TOLEDO - LUCAS COUNTY PLAN COMMISSIONS

REF: PUD-11007-23
DATE: January 11, 2023

SUBJECT: Amendment to Planned Unit Development granted by Ord. 550-12, 87-17, 30-21 and 611-22

PUD-11007-23

SITE PLAN - MAGNIFIED

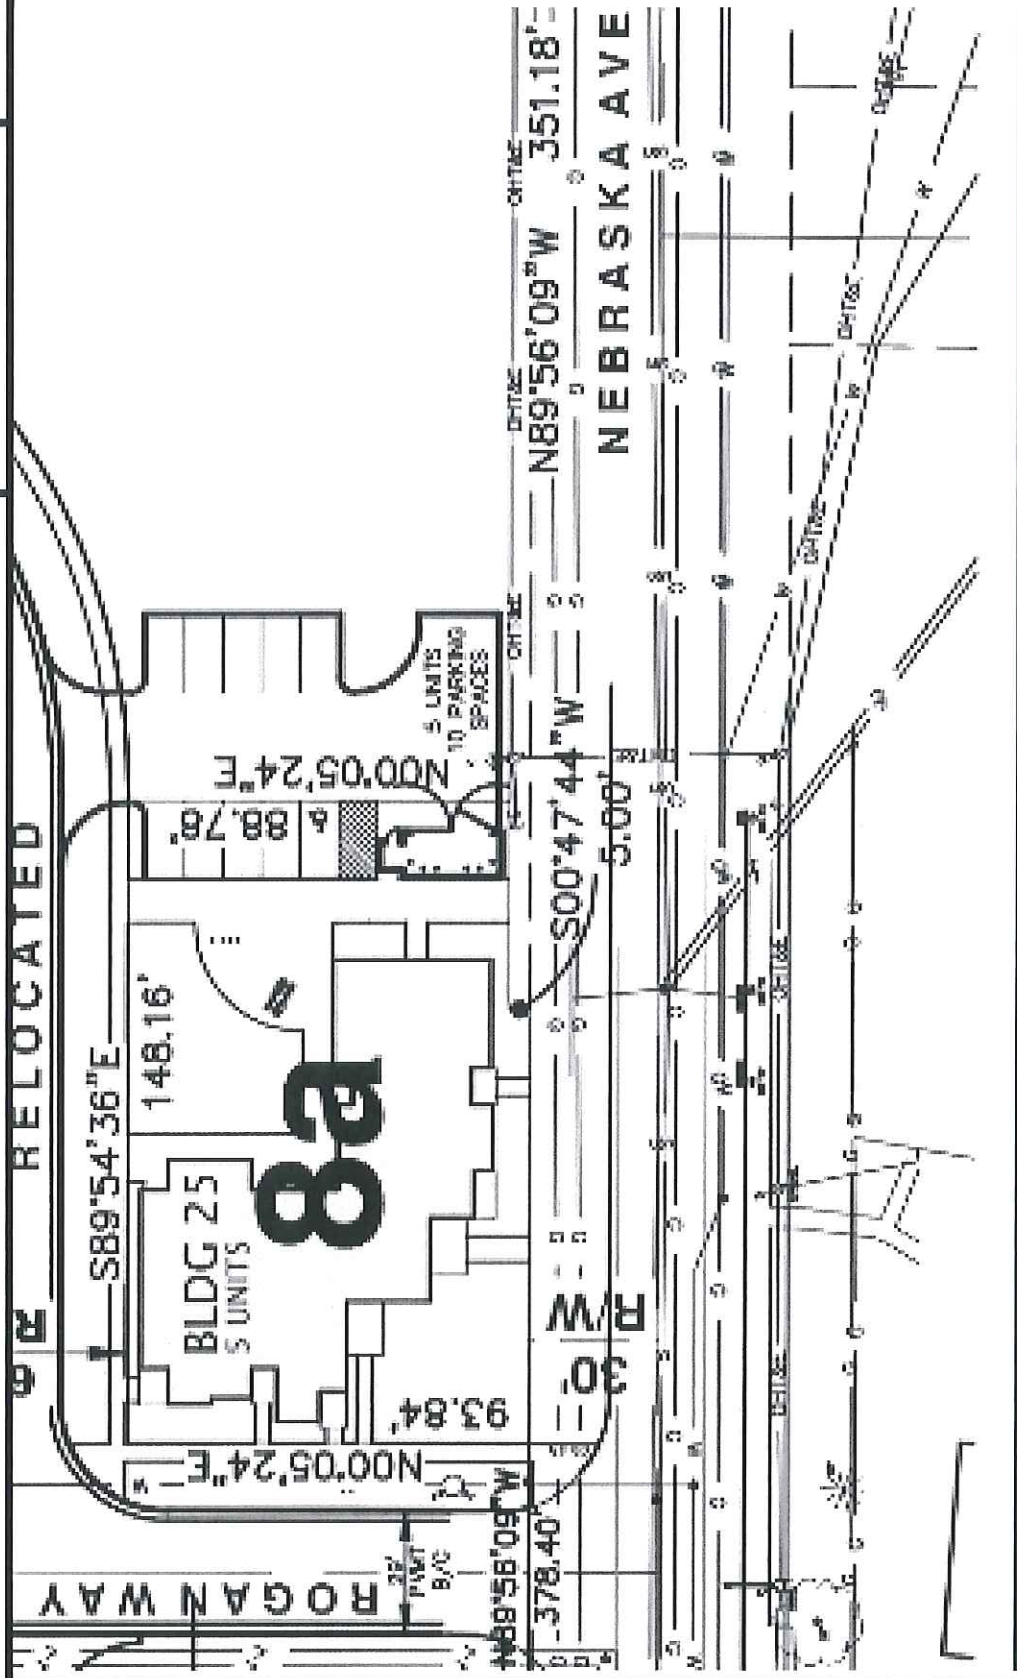
Pursuant to TMC§1107.0300, the required parking for multi-family housing is one (1) and one-half (1 ½) spaces for every one (1) dwelling unit, plus one (1) space per ten (10) units for visitor parking. For five (5) dwelling units eight (8) parking spaces are required plus one (1) space for visitor parking for a total of nine (9) spaces. The submitted site plan shows ten (10) parking spaces. Additionally, one (1) bicycle parking slot per ten (10) parking spaces is required. Four bicycle parking spaces are indicated on the submitted site plan.

A portion of the total number of required off-street parking spaces must be specifically designated, located, and reserved for use by persons with physical disabilities. According to the table in TMC§1107.1701 – *Number of Required Parking Spaces for Persons with Disabilities*, the applicant is required to provide at least one (1) van accessible space with an eight-foot (8') drive aisle for persons with physical disabilities. The site plan shows one (1) accessible parking space included in the total number of parking spaces for the proposed multifamily housing.

Calculations conclude that a site comprised of 20.0 acres is permitted to accommodate a total of 464 units. The proposal of additional five (5) units is well below the allowed number of dwelling units and the proposal is in compliance. No more than forty percent (40%) of gross site acreage shall be devoted to coverage by buildings, structures, street pavement, driveway and parking area pavement (TMC§1106.0302(B) – Intensity and Dimensional Standards Table). The site plan submitted complies with the regulation.

35. Off-street parking shall be provided pursuant to Off-Street Parking Schedule "A," (TMC§1107.0304). Minimum number of off-street parking spaces required for multi-family housing is one (1) and one-half (1 ½) spaces for every one (1) dwelling unit, plus one (1) space per ten (10) units for visitor parking. A total of nine (9) parking spaces is required for the use. The submitted site plan shows ten (10) parking spaces. **Acceptable as depicted on submitted site plan.**

36. Bicycle parking slots shall be provided pursuant to Off-Street Parking Schedule "A," (TMC§1107.0300). Minimum number of bicycle parking slots required for a multifamily housing is one (1) bicycle parking per ten (10) parking spaces. Four (4) bicycle parking spaces are indicated on the submitted site plan. **Acceptable as depicted on submitted site plan.**

37. Any spaces reserved for the use by persons with physical disabilities shall adhere to the standards outlined in TMC§1107.1700. One (1) van accessible space with an eight-foot (8') drive aisle is required. **Acceptable as depicted on submitted site plan.**

NEW 5
UNIT
BUILDING
A3

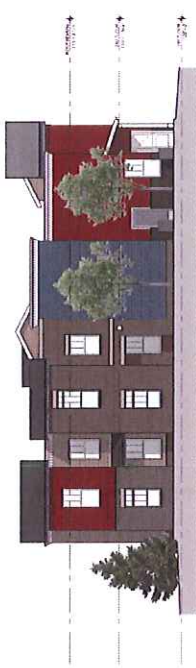
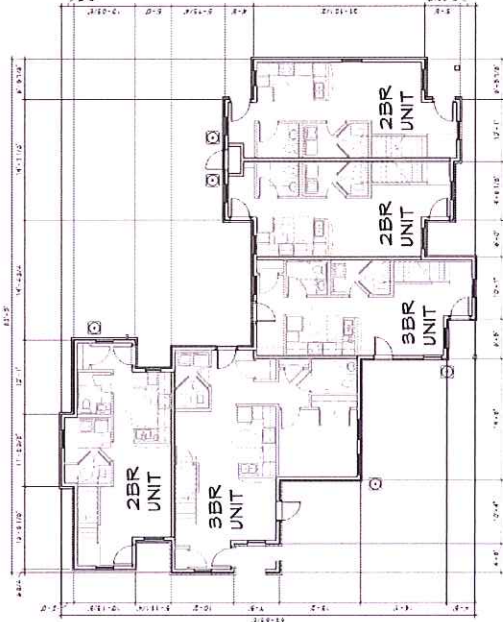
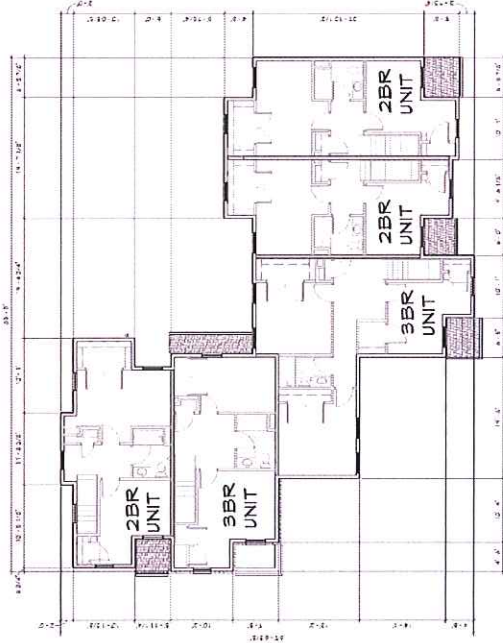
The intent of building design standards is to ensure a base level of quality architecture that contributes to the established architectural character of an area. Exterior walls are articulated in order to add architectural interest and variety and avoid the effect of a single, long or massive wall with no relation to human scale. The building design reduces its mass by dividing the building into smaller masses through the use of reveals and projections and changes in texture and color of wall surfaces. The proposed designs are compliant with building elevations approved via Ord. 87-17. The proposed design is in compliance with the Zoning Code.

- k. The location and direction of any proposed **lighting (any lighting is to be directed away from adjacent residential properties).**
41. Building elevations are subject to TMC§1109.0500 – Building Façade Materials and Color. **Proposed elevations are acceptable as depicted.**

LANDSCAPE PLAN

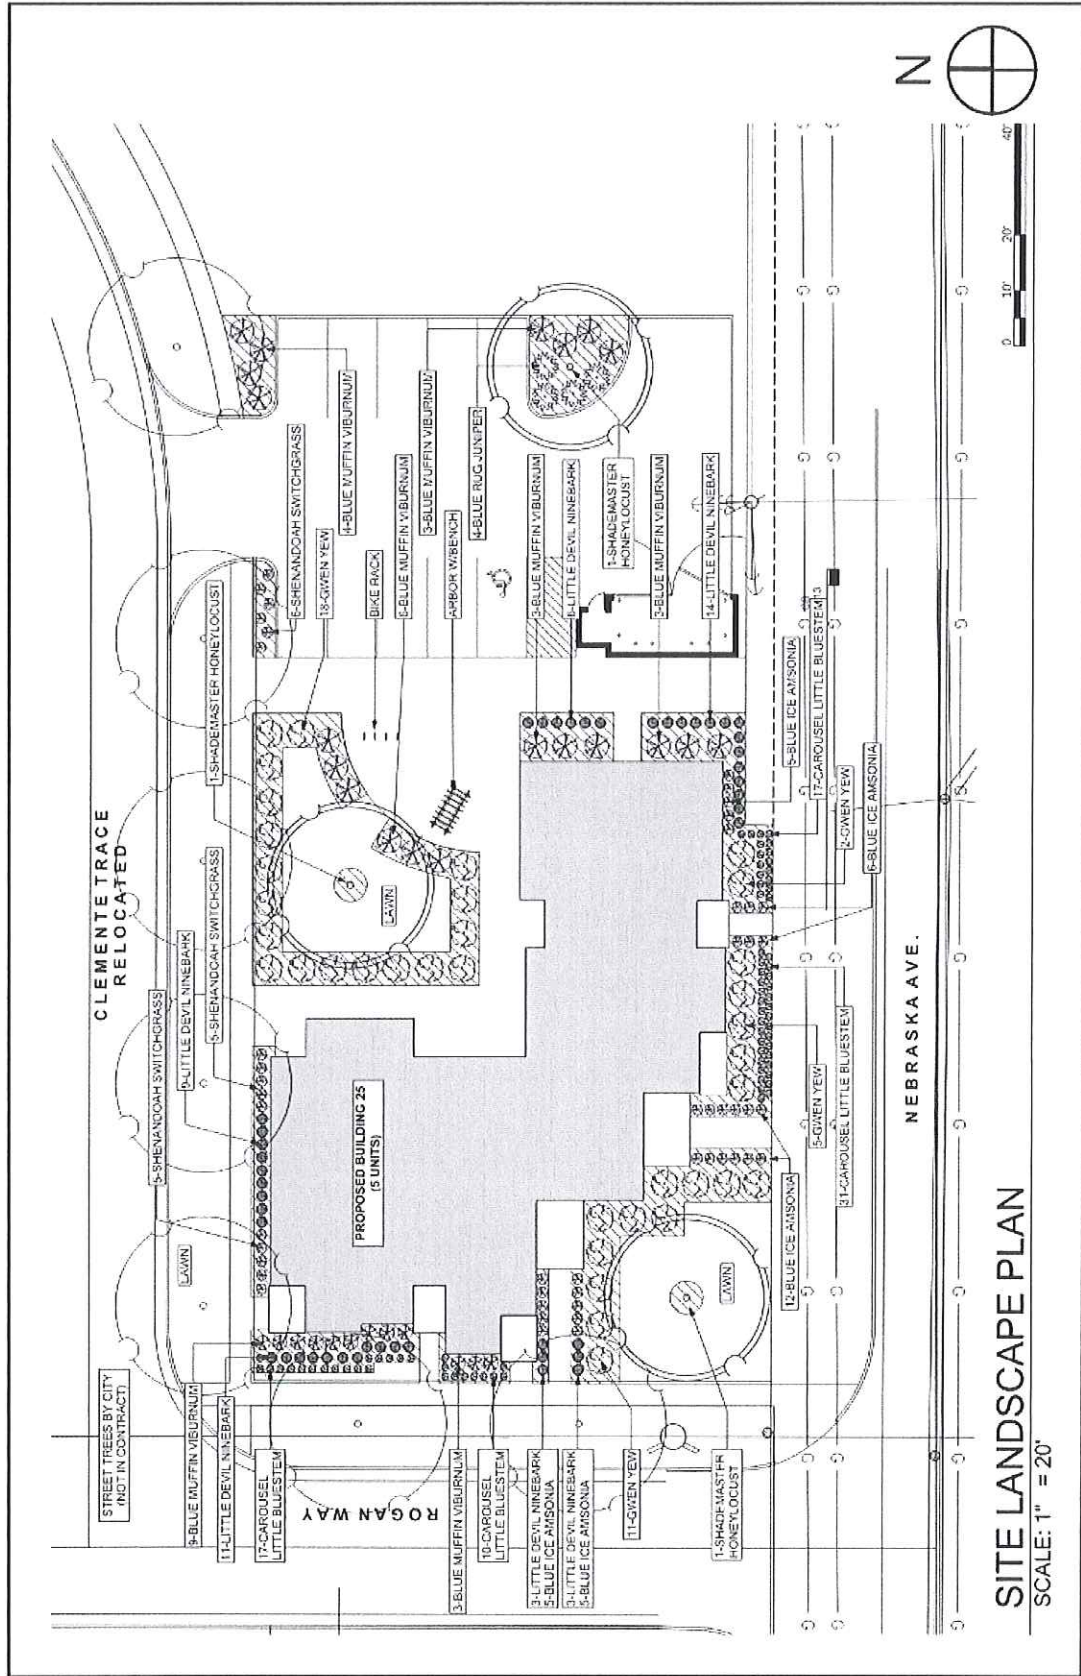
Per TMC§1103.1010(G), landscaping for a PUD shall be reviewed and approved in accordance with the procedures of Chapter 1108-Landscaping and Screening. **TMC§1108.0202** requires a minimum of fifteen-foot (15') of landscaped frontage greenbelt along public rights-of-way. At least one tree must be provided for every 30 feet of lot frontage or fraction thereof. The frontage greenbelt shall also include a solid evergreen hedge to screen parking in the front of the property and prevent headlights from being seen from the right-of-way. A fifteen-foot (15') frontage greenbelt buffer is required along Nebraska Avenue, Rogan Way and Clemente Trace. The submitted site plan shows an eight-foot (8') buffer along Nebraska Avenue and a portion of Rogan Way. A three-foot (3') buffer is also shown along Clemente Trace. The applicant is requesting a waiver from the fifteen-foot (15') frontage greenbelt requirement. The submitted site plan also shows five (5) and three (3) trees along Clemente Trace and Rogan Trace respectively.

Parking lot landscaping is essential to prevent headlights from being seen from public rights-of-way, curb the urban heat island effect, and to beautify the site. TMC§1108.0204 - *Parking Lot Landscaping (Interior and Perimeter)* applies to RM36 Multi-Dwelling Residential off-street parking lots containing five (5) or more off-street parking spaces. **TMC§1108.0204(B)(9)** requires perimeter landscaping to be installed along any parking lot area adjacent to a street, place, or driveway, or which is visible from an immediately adjacent property, and must include a continuous shrub row with a minimum height of eighteen inches (18"). Perimeter landscaping must consist of a landscape area at least ten-feet (10) in width, exclusive of sidewalks, walkways, trails, or right-of-way and must be located between the parking lot and the property line. The site plan shows nine shrubs along Clemente Trace providing perimeter screening for the parking lot.

In addition to that, the total interior landscaping required for parking lots is twenty (20) square feet per parking space. The site's parking lot contains a total of ten (10) parking spaces, which requires a minimum of 200 square feet for interior parking lot landscaping. Additionally, two (2) canopy trees and six (6) shrubs are required to be installed in interior landscape areas for each ten (10) parking spaces. A total of two (2) trees and six (6) shrubs are required in the interior parking. This is acceptable as depicted on the submitted landscaping plan.

Finally, one (1) tree per 500 square feet of building coverage, or fraction thereof, is required for all structures. Additionally, foundation plantings and landscaping at major building entrances are required. The submitted landscape plan shows the required interior site landscaping throughout the site and along the building foundations.

- a. A fifteen-foot (15') frontage greenbelt buffer is required along Nebraska Avenue, Rogan Way and Clemente Trace. At least one tree must be provided for every 30 feet of lot frontage or fraction thereof. The frontage greenbelt shall also include a solid evergreen hedge to screen parking in the front of the property and prevent headlights from being seen from the right-of-way. The submitted site plan shows an eight-foot (8') buffer along Nebraska Avenue and a portion of Rogan Way. A three-foot (3') buffer is also shown along Clemente Trace. Five (5) and three (3) trees are indicated in the greenbelt buffer along Clemente Trace and Rogan Trace respectively. **Not acceptable as depicted on landscaping plan. Applicant shall obtain approval to a waiver from TMC§1108.0202(B)(3);**

- b. Perimeter landscaping must be installed along any parking lot area adjacent to a street, place, or driveway, or which is visible from an immediately adjacent property, and must include a continuous shrub row with a minimum height eighteen inches (18"). **Acceptable as depicted on landscaping plan;**

- c. Interior landscaping required in parking lots is 20 square feet per parking and stacking space. Two (2) canopy trees are required to be installed in interior landscape areas for each ten (10) parking spaces within the parking lot. Six (6) shrubs are required to be installed in interior landscape areas of each ten (10) parking spaces within the parking lot. **Acceptable as depicted;**

- d. One 2-inch caliper tree for every 5,000 square feet of building coverage shall be required. Five (5) trees are required for this site. **Not acceptable as depicted on landscaping plan. Applicant shall provide square footage of proposed building to determine required number of trees.**

- e. Landscaped areas may not contain bare soil, aggregated stone or decorative rock. Any ground area must be covered with hardwood mulch, grass or other vegetative ground coverage. **Acceptable as depicted on landscaping plan;**

- g. The location, number, height, diameter and species of any materials to be planted and maintained, as well as the location and number of any existing trees to be retained, trees, shrubs, and landscape materials shall meet the standards included in TMC 1108.0400 Landscape Materials Standards. **Acceptable as depicted on landscaping plan;**

Approve a waiver to reduce required frontage greenbelt buffer to eight feet (8') along Nebraska Avenue and a portion of Rogan Way and three feet (3') buffer along Clemente Trace due to limited space.
